Access Compliance Report Public Rights-of-Way (Curb Ramps)

Main Street: WOODSTOCK_RD Cross Street: MONTECITO_RD Location: NW

ADA ID: RPRK211209125939 Ramp Type: Type 1 - Perpendicular Diagonal Initial Pass/Fail: Fail Overall Compliance: No Severity Score: 2

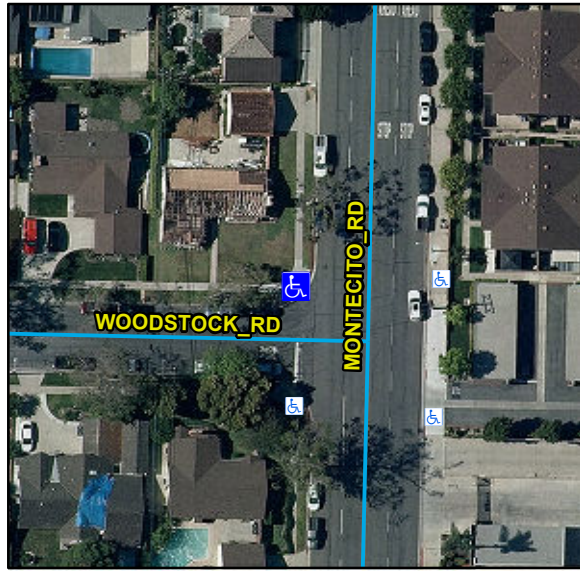
Compliance	Description	Data	Compliance	Description	Data
N/A	Ramp Length (in)	114	N/A	Flare Type LT	
Yes	Ramp Width (in)	48			N/A
Yes	Ramp Run Slope (%)	3	N/A	Flare Slope LT (%)	N/A
No	Ramp Cross Slope (%)	2.2	N/A	Flare Traversable LT	N/A
N/A	Landing Present	N/A	N/A	Flare Type RT	
N/A	Landing Length (in)	N/A			N/A
N/A	Landing Width (in)	N/A	N/A	Flare Slope RT (%)	N/A
N/A	Landing Run Slope (%)	N/A	N/A	Flare Traversable RT	N/A
N/A	Landing Cross Slope (%)	N/A	N/A	DWS Provided	N/A
N/A	Landing Movement Obstructed?	N/A	N/A	DWS Contrast	N/A
	Landing Movement Type	N/A	N/A	DWS Length (in)	N/A
N/A	Landing Shared	N/A	N/A	DWS Full Width	N/A
N/A	Clear Space	Yes	N/A	DWS Offset Left (in)	N/A
N/A	Clear Space To Crosswalk (in)	N/A	N/A	DWS Offset Right (in)	N/A
N/A	Marked Crosswalk 1	No	N/A	Marked Crosswalk 2	No
	Crossing 1 Direction	S		Crossing 2 Direction	E
	Marked Crosswalk 1 Width (in)	N/A		Marked Crosswalk 2 Width (in)	N/A

N/A	Ramp Inside Crosswalk 1	N/A	Yes	Ramp Inside Crosswalk 2	N/A
	Crossing 1 Slope (%)	9.7		Crossing 2 Slope (%)	5.4
	Crossing 1 Cross Slope (%)	2.7		Crossing 2 Cross Slope (%)	2.4
N/A	Gutter Ponding	N/A	No	Curb Slope	11.3
Yes	Gutter Lip Height (in)	0		Road Run Slope (%)	3.6
N/A	Gutter Run Slope (%)	N/A		Road Cross Slope (%)	7.6
N/A	Gutter Cross Slope (%)	N/A			
Yes	Overall Surface Condition: Acceptable		No	Perp Joint Present	No
	Cross Gutter Present?	No		Spandrel Present?	No
	Replace Cross Gutter?	N/A		Replace Spandrel?	N/A

Remove & Replace Curb Ramp With Two New Directional Ramps or Equivalent.
